Motion #1: Potential Amendments to the Sept. 14, 2012 Draft ERC Regulating Plan

Staff recommended corrections to the Sept. 14 draft E. Riverside Corridor Regulating Plan:

Figure 1-3: East Riverside Corridor Roadway Type Map

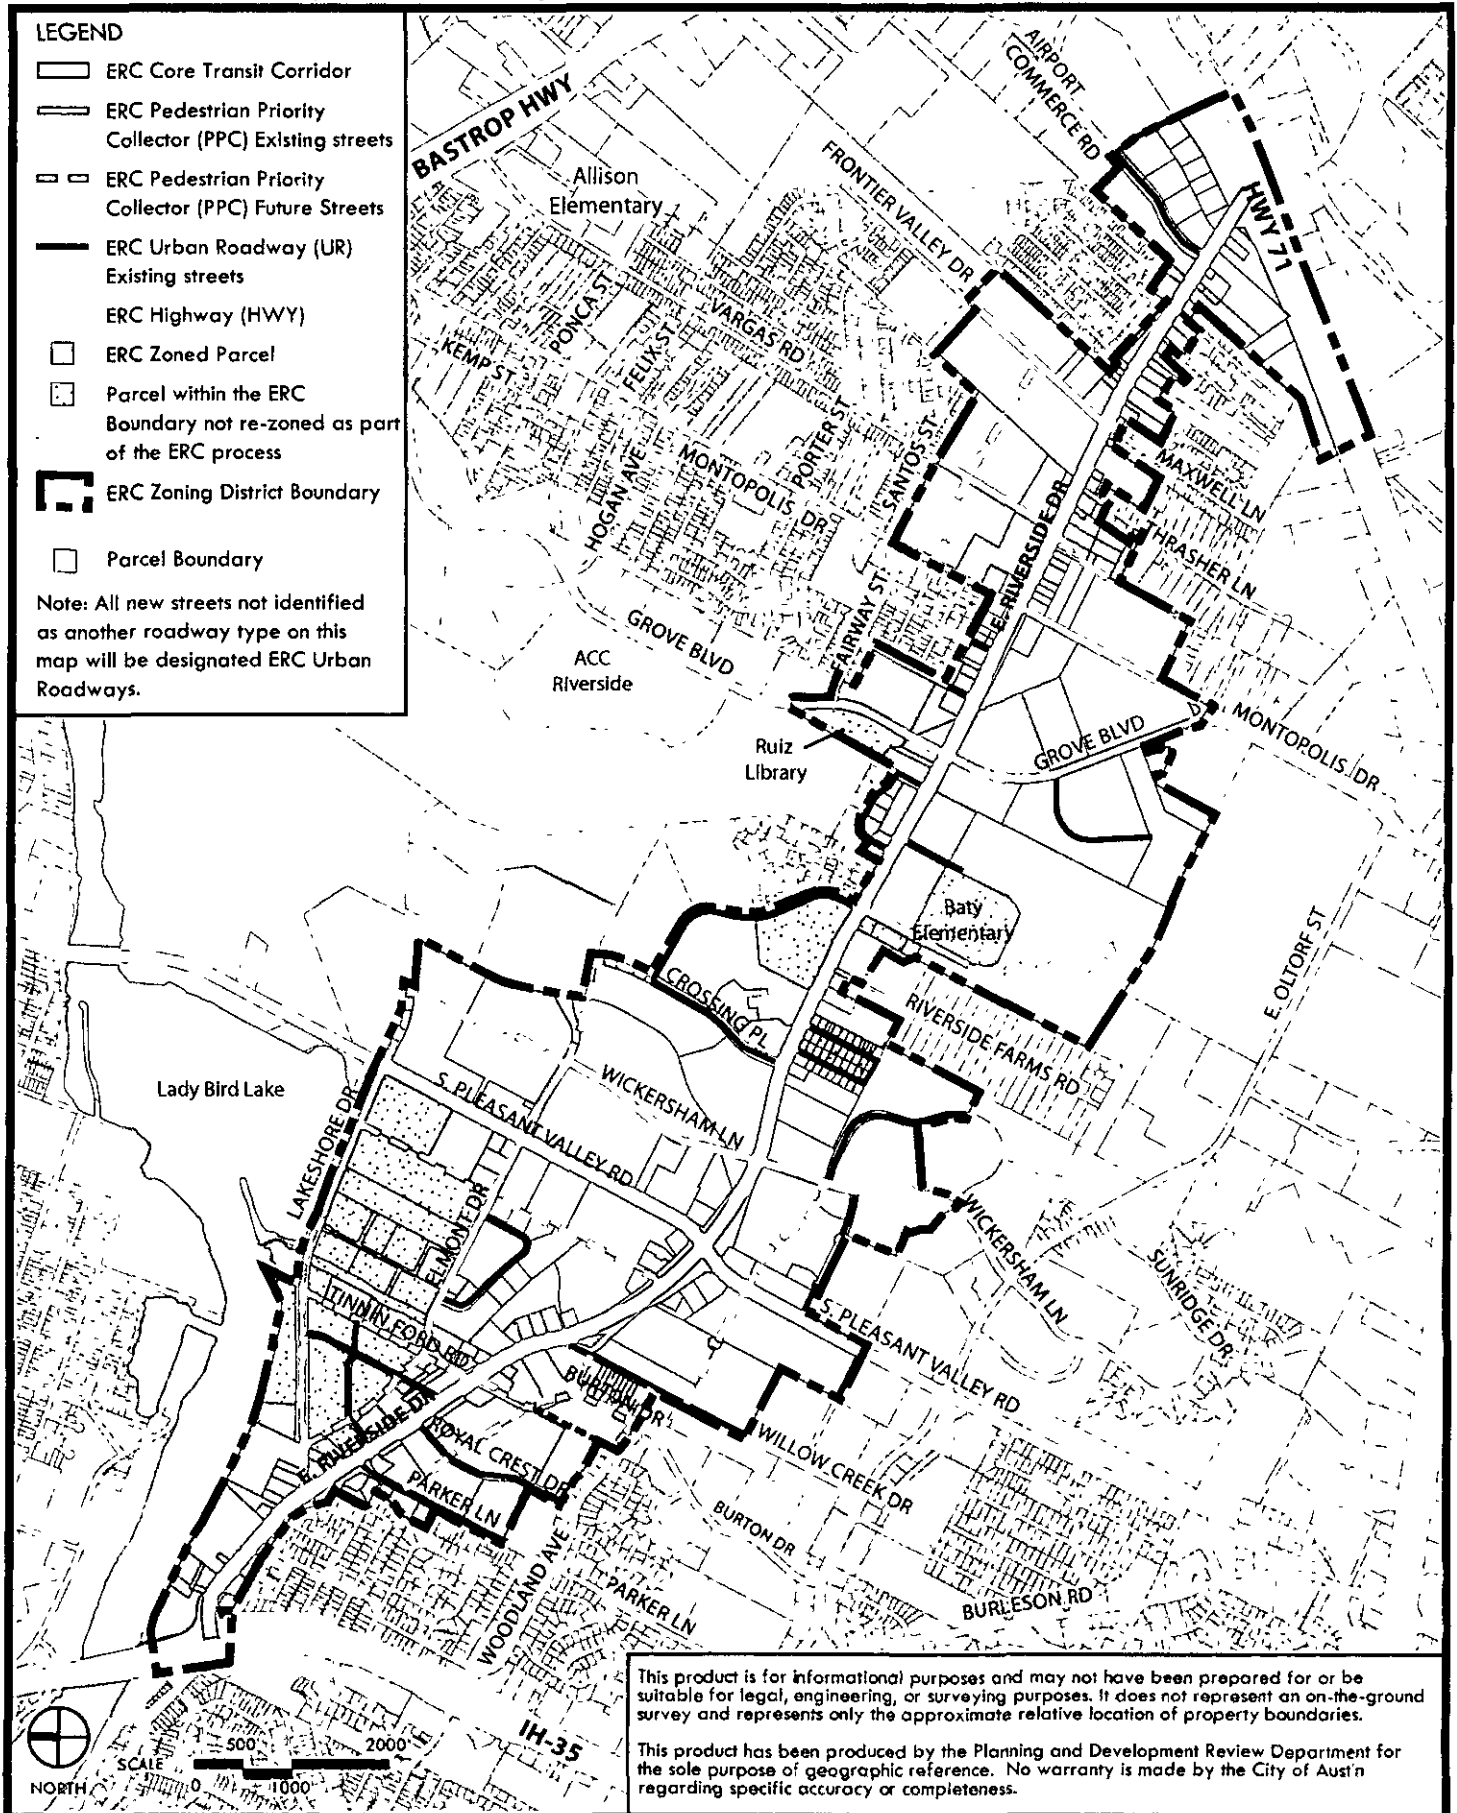
- C.2. P. 15, Modification to collector street map to account for an existing drainage way. See revised Figure 1-5: East Riverside Corridor Collector Street Map (Nov. 8, 2012 DRAFT – see attached) and associated Figure 1-3: East Riverside Corridor Roadway Type Map (Nov. 8, 2012 DRAFT– see attached).

Figure 1-14: East Riverside Corridor (ERC) Future Land Use Map (FLUM)

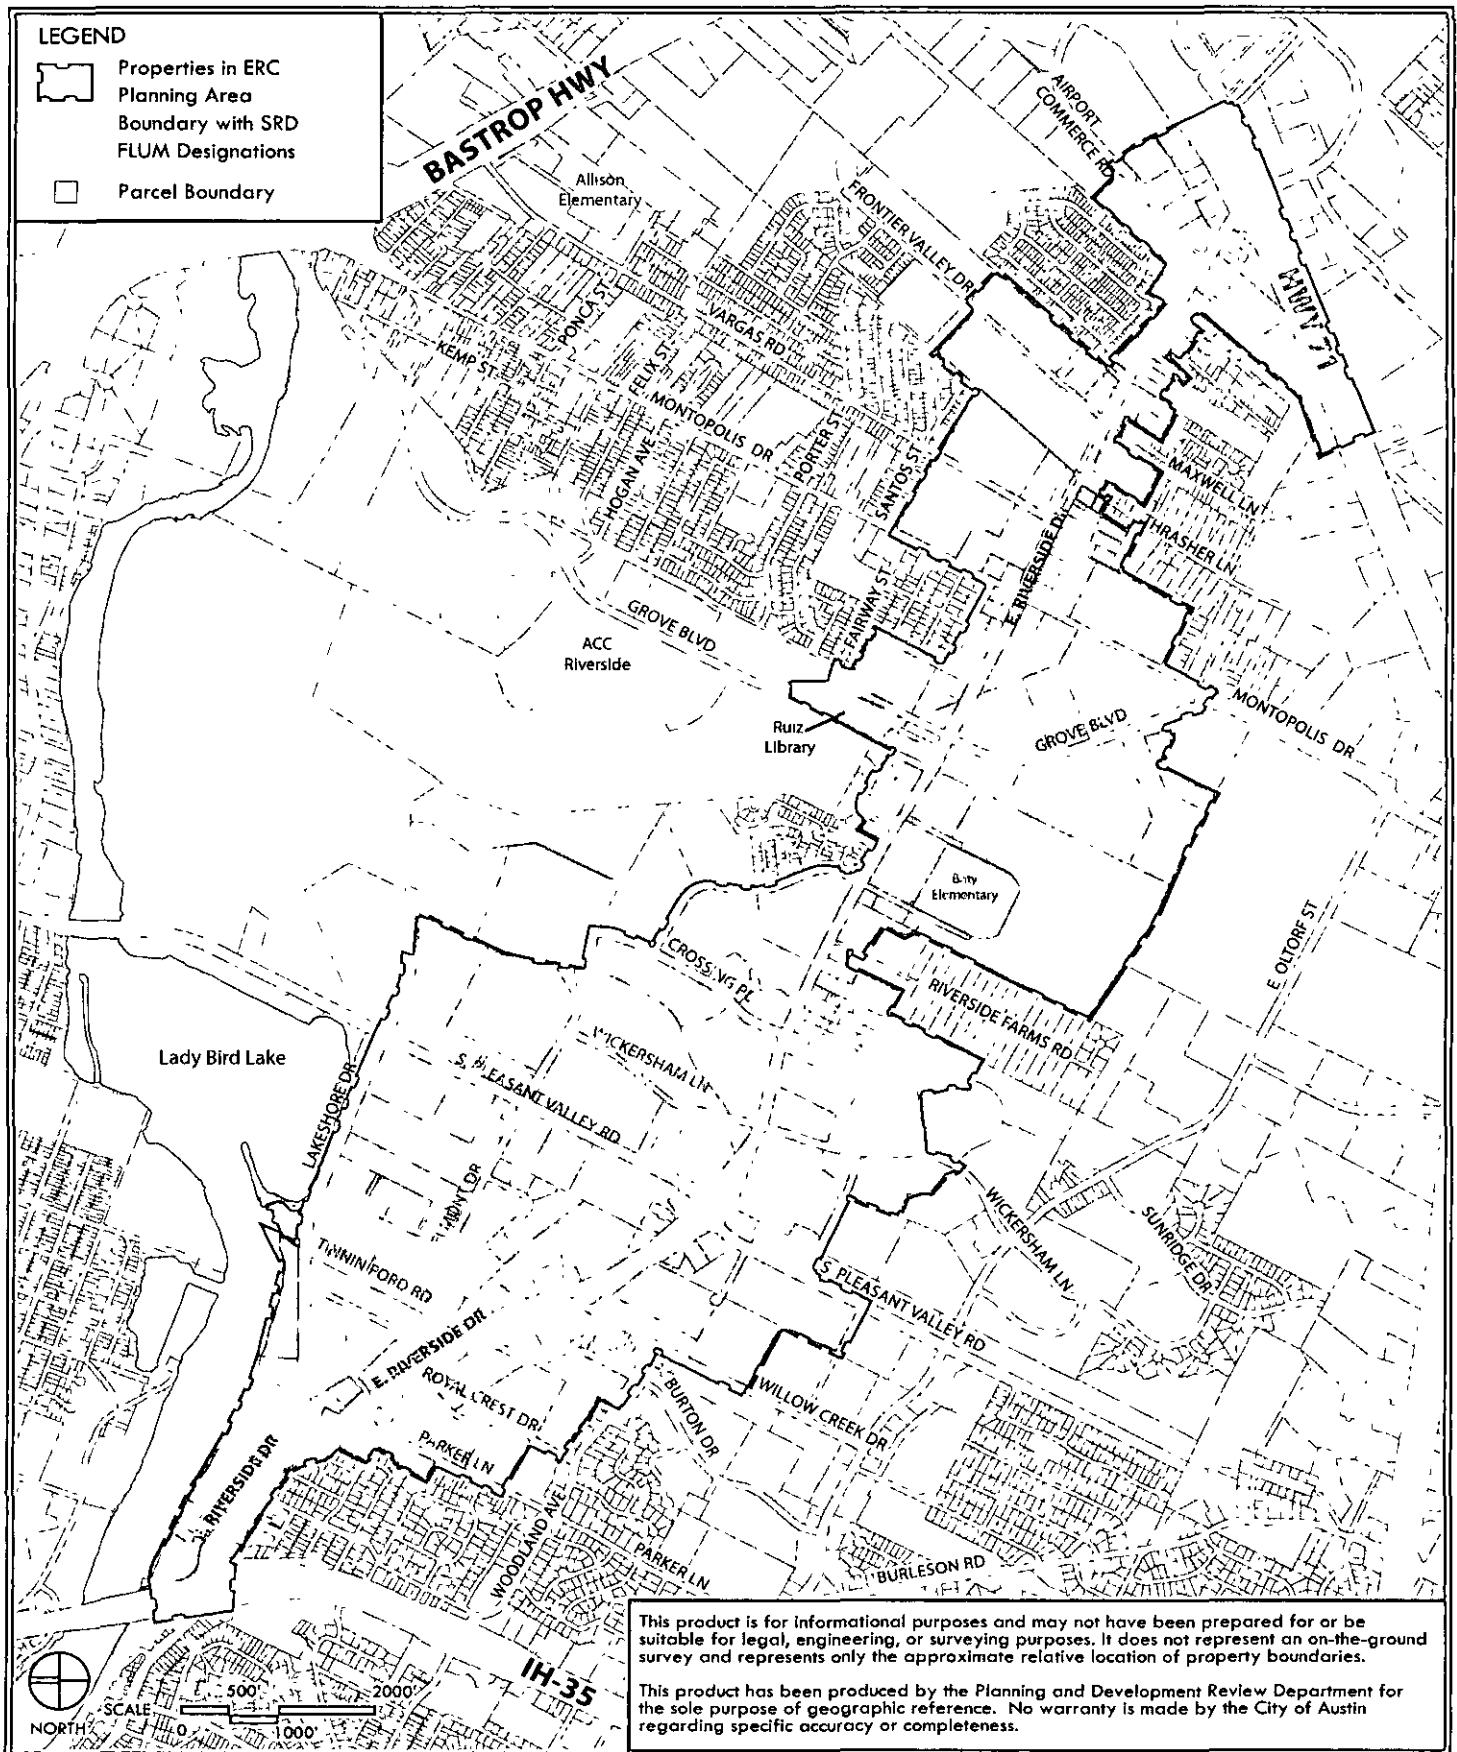
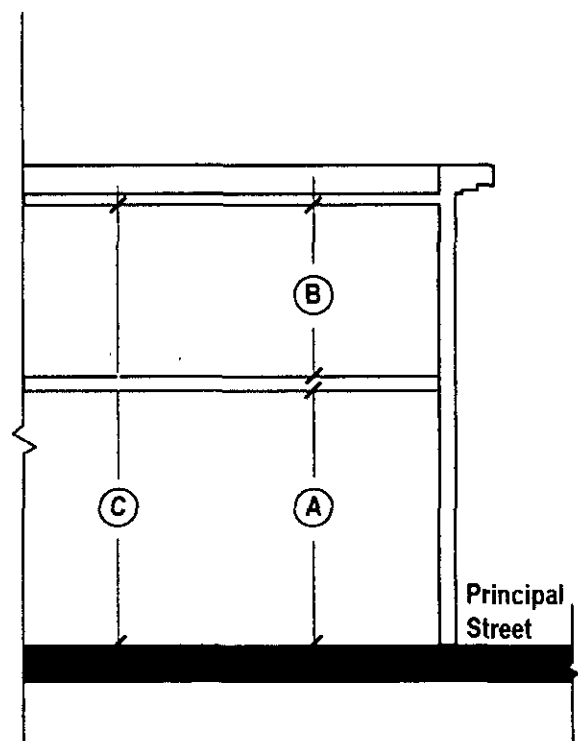
- A.3. P. 24. Add new Figure 1-14: East Riverside Corridor (ERC) Future Land Use Map (Nov. 8, 2012 DRAFT – see attached) (**Note:** Added for clarification purposes.)
